[Docket No. FAA-2018-0479; Product Identifier 2016-NE-23-AD; Amendment 39-19369; AD 2018-17-15]

Airworthiness Directives; Honeywell International Inc. Turboprop and **Turboshaft Engines**

Figure 2 to Paragraph (h) of this AD. Combustion Chamber Case Assembly with One-Piece Bleed Pad with P3 Boss

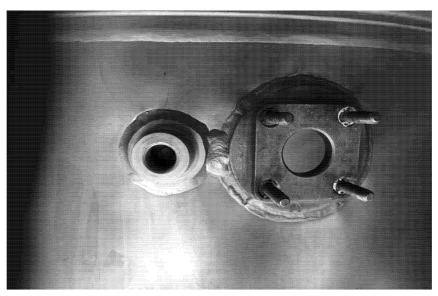
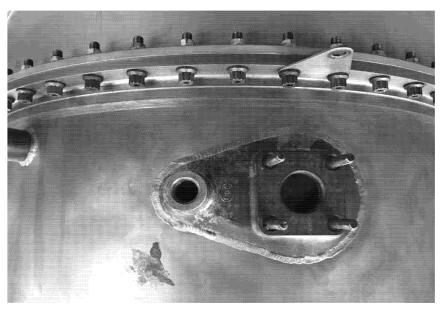
- (1) TPE331 engines modified by STC SE383CH may be defined as the "Super 1" and "Super 2" for the compressor modification of the TPE331–1 and the TPE331–2, –2U, and –2UA engine models, respectively.
- (2) Figures 1 and 2 to paragraph (h) of this AD illustrate the appearance of combustion chamber case assembly, P/N 893973–5, without and with, respectively, the one-piece bleed pad with the P3 boss.

After the effective date of this AD, do not install a combustion chamber case assembly, P/N 869728–1, 869728–3, or 893973–5, in TPE331–3U, –3UW, –5, –5A, –5AB, –5B, –6, and –6A engine models or in TPE331–1, –2, and –2UA engine models modified by National Flight Services, Inc., STC SE383CH, unless the combustion chamber case assembly has a one-piece bleed pad with P3 boss.
